WILLIAMSON COUNTY, TEXAS
CHANGE ORDER NUMBER: 2

Project:	<u>1604-075</u>
Roadway:	<u>CR-110 South</u>
CSJ Number:

**County Road 110 South
Williamson County Project No. 1604-075**

Change Order No. 2

REFERENCE: Plan Sheet 154 and Cross Section sheets 71 & 80

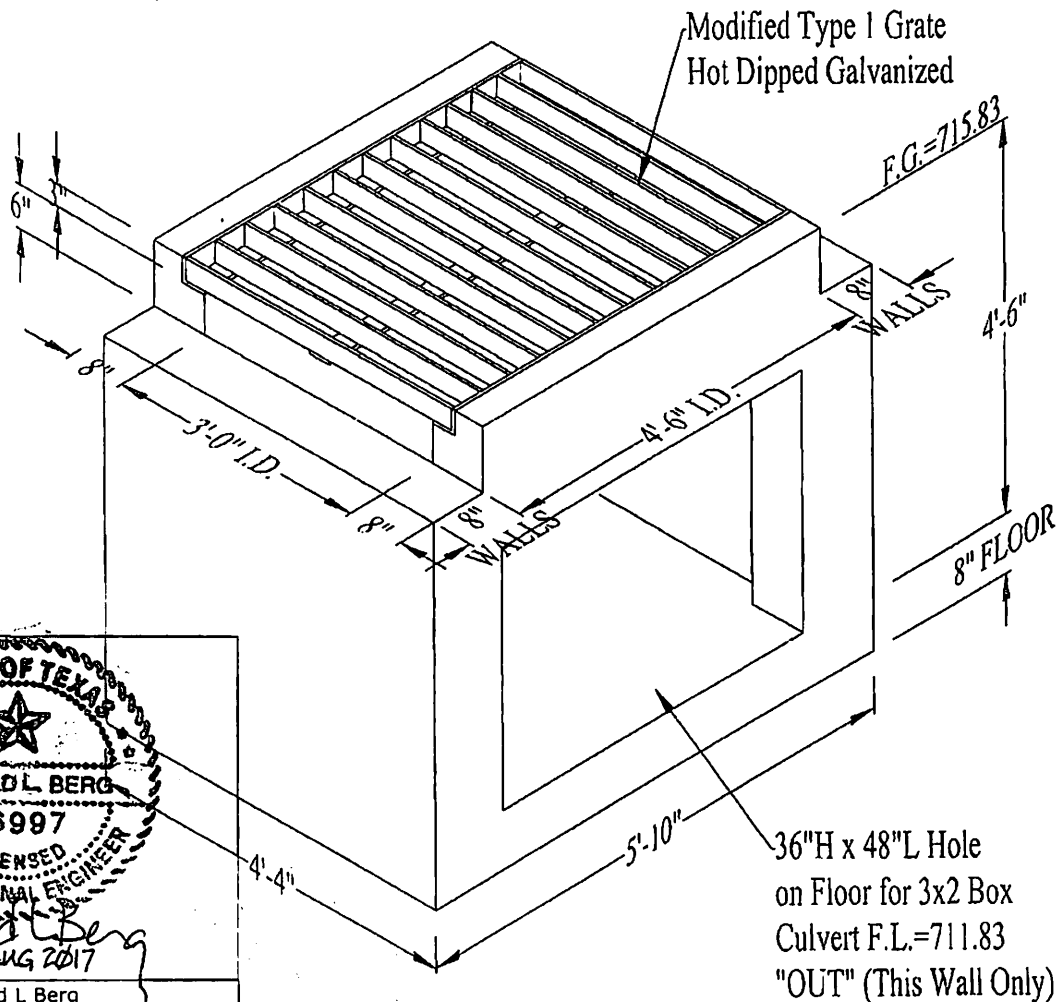
PROBLEM: Culvert Flow lines are 2 to 3' lower than ditch lines shown in the cross sections, creating much deeper back slopes. ROW location on sheet 154 for culvert 5 does not match cross sections.

Delete parallel wingwalls for Culverts 4 & 5, replace with drop inlets. Reconfigure ditch grades to accommodate drainage upstream and downstream in east ditch line.

Please refer to culvert grading shown on sheet 156 for structure 5. Sheet 154 has been revised to show a grate inlet on upstream side of structure 4.

3'-0" x 4'-6" x 4'-6" I.D.
Modified TxDOT Type 1 Drop Inlet
(Techline~CR 110 South)

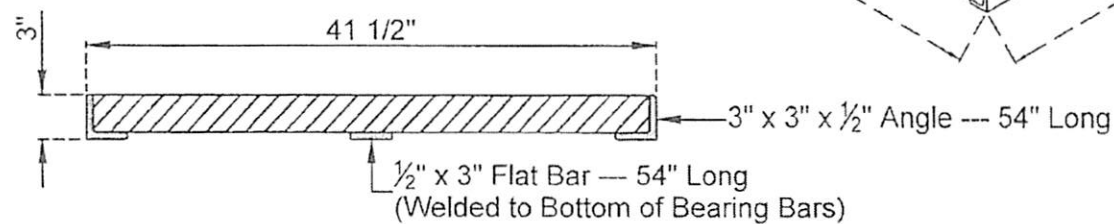
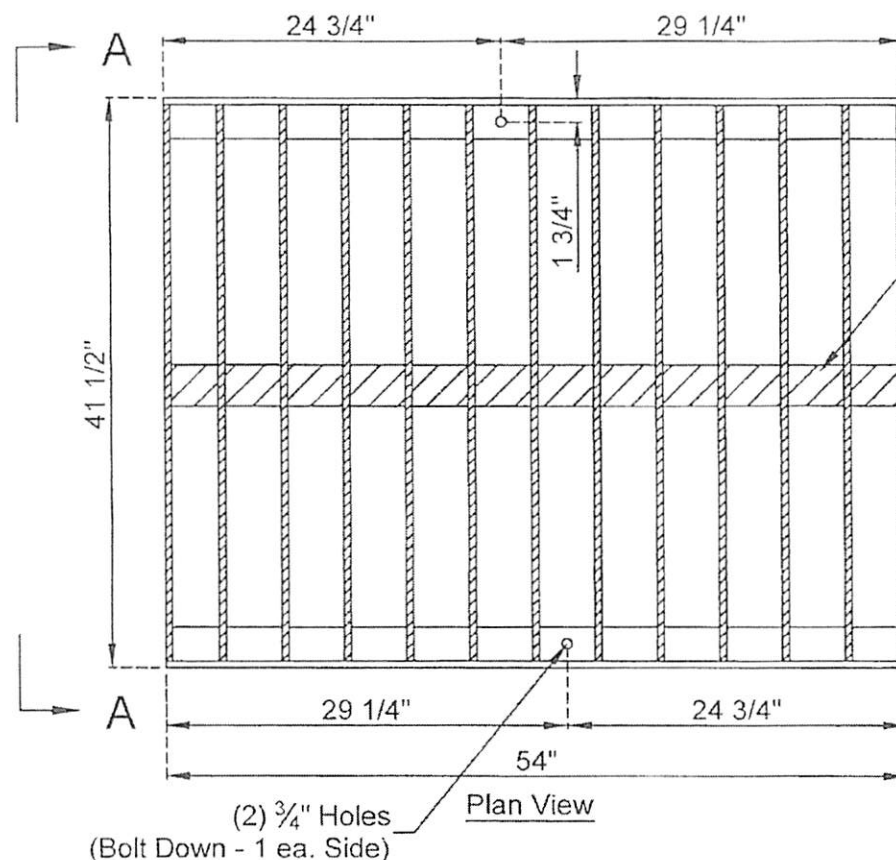
This Change Order substitutes a wingwall with a special drop inlet due to safety slope reasons. The proposed culvert upstream flowline was approximately 4' below ditch profile grades, which would have resulted in an extremely steep backslope at the end of the culvert. This Change Order also addresses over-runs and under-runs for various waterline components and includes substituting the HDPE bore pipe for steel encasement pipe at the request of Seminole Pipeline.
